## KNOXVILLE HISTORIC ZONING COMMISSION STAFF REPORT - CERTIFICATE OF APPROPRIATENESS APPLICATION

FILE NO.: 11-D-19-HZ

PROPERTY LOCATION: 203 16th St. /

- After-the-fact review of demolition of rear shed-roof sunporch
- After-the-fact review of reconstruction of 6' x 12' foundation; foundation to be constructed of concrete masonry units with a brick façade to match rest of house
- Construction of  $6' \times 12'$  rear addition, to feature shed roof (4/12 pitch, clad in asphalt shingles), fiber cement board siding, and one 30" x 30" window on rear (west) elevation. Addition will have 6'' offset from left (north) side of house.

Rear elevation showing addition in progress

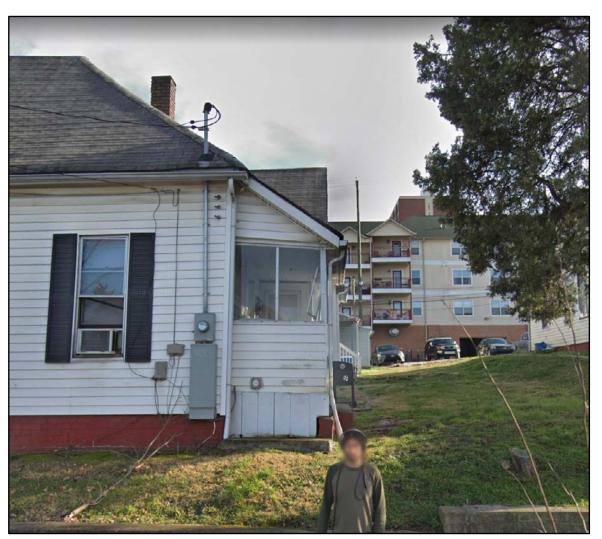
- 4. At the time of the application, the sunporch foundation and framing had been reconstructed to be flush with the existing west elevation. Guidelines recommend an offset to distinguish new construction from the historic house; moreover, increasing the footprint of the rear addition could create or increase a lot coverage nonconformity. The rear addition should maintain the exact footprint of the sunporch.

Staff recommends approval of the work as proposed, with the condition that the footprint of the proposed rear addition match that of the historic sunporch.

Rear – Picture of 207 16<sup>th</sup> St. Matching style

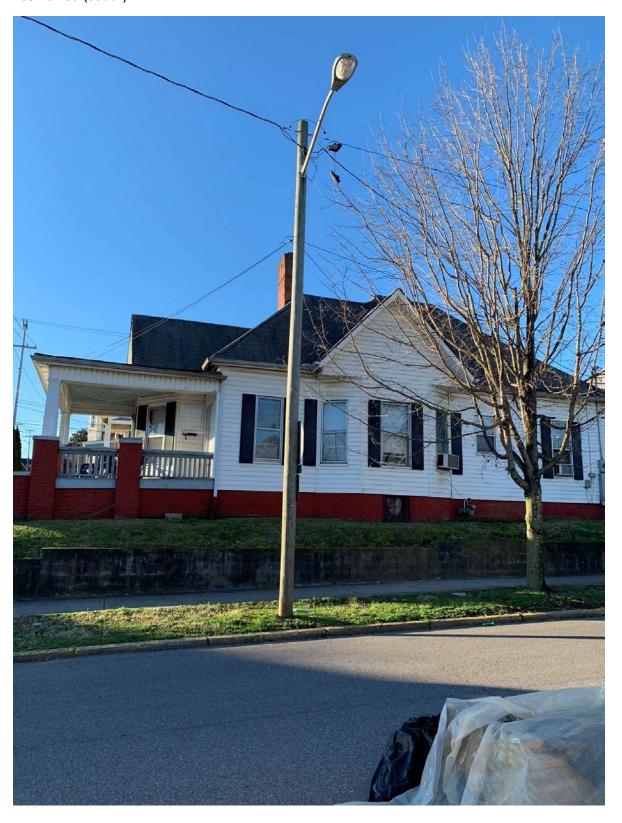
Applicant has provided images of small shed-roof addition on rear elevation of 207 16th Street as example.
